Re: *Addendum No. 2*
Forest Lawn Stormwater Park
ABC Water and Stormwater District

Date: May 29, 2024

Replace *Type C Flexible Pavement Replacement Detail* on Sheet 5 of 43 with the enclosed Exhibit A detail.

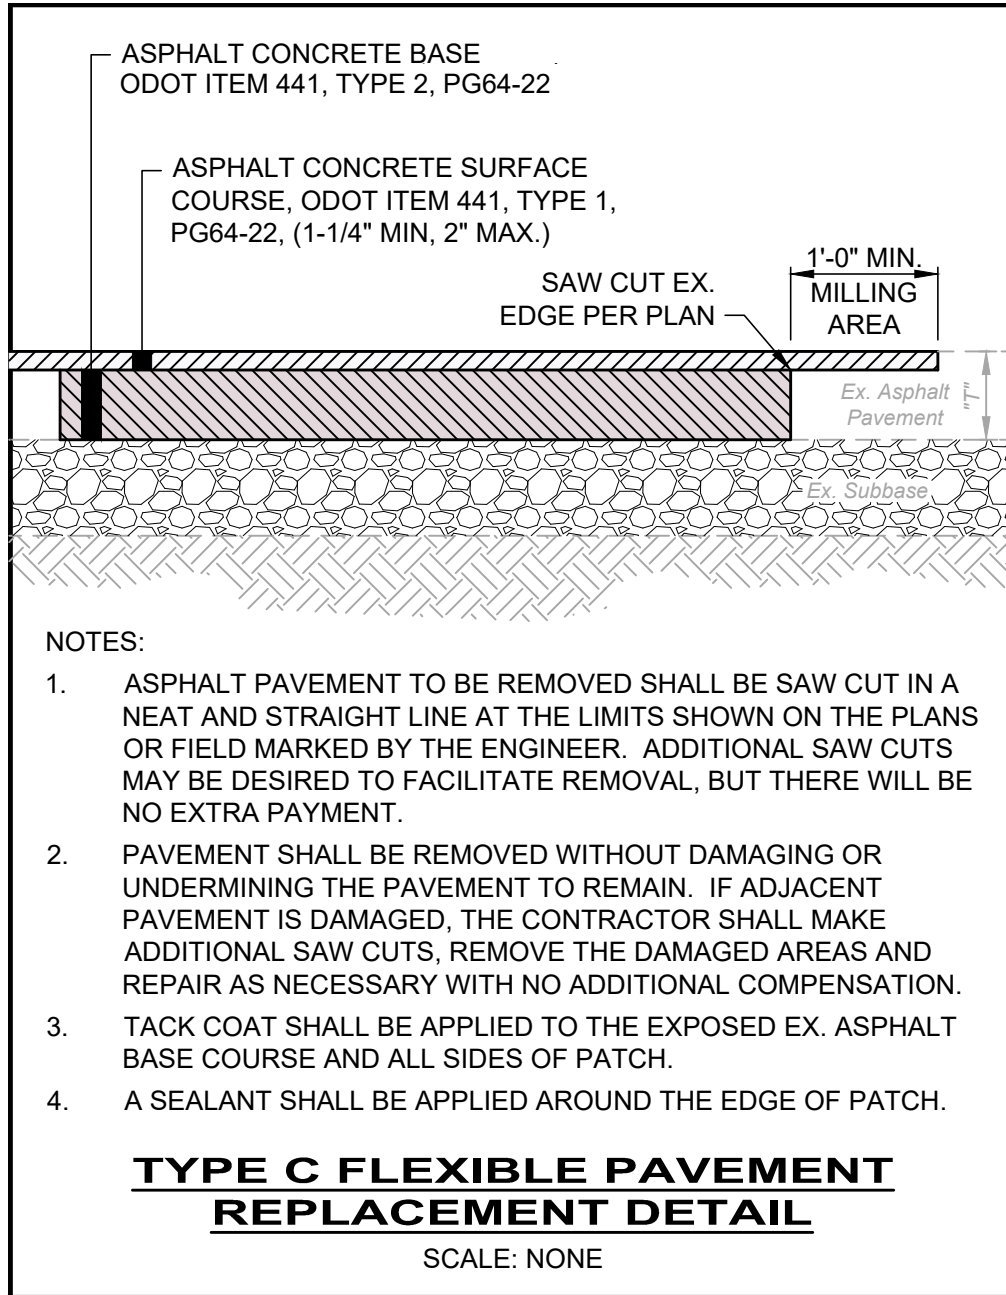
Q15. Upon review of the plans and bid form there are details that include #301 Asphalt, however there are no quantities for this item on the bid forms. Please advise

A15. That is correct, we do not have a line item for #301 asphalt. Our detail is structured as “Type C Pavement Replacement”. Item 2.37 of the Prices to Include detail reference this information and unit price is to include all pavement courses. #301 Asphalt is indicated if the existing base thickness is more than 3”, or #441 if existing materials is less than 3” thick. In response to this question, we have reviewed and updated the detail and instead are specifying as part of the pavement that #441 Type 2 material be used for intermediate course. Thus, the option of #301 is omitted.
